Addendum 128 – UN Regulation No. 129

Revision 3 - Amendment 6

Supplement 7 to the 02 series of amendments – Date of entry into force 22 June 2022

Uniform provisions concerning the approval of Enhanced Child Restraint Systems used on board of motor vehicles (ECRS)

Figure 3
Minimum distance for lateral impact

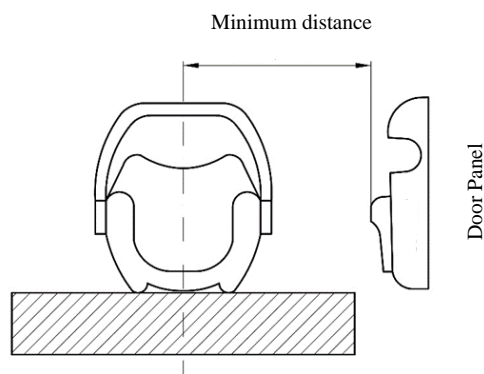
Paragraph 7.1.3., amend to read:

For each test, the initial position of the side impact door panel relative to the bench shall be adjusted according to the minimum distance between the vehicle's door panel and the centre of the seating position as shown in Figure 3.
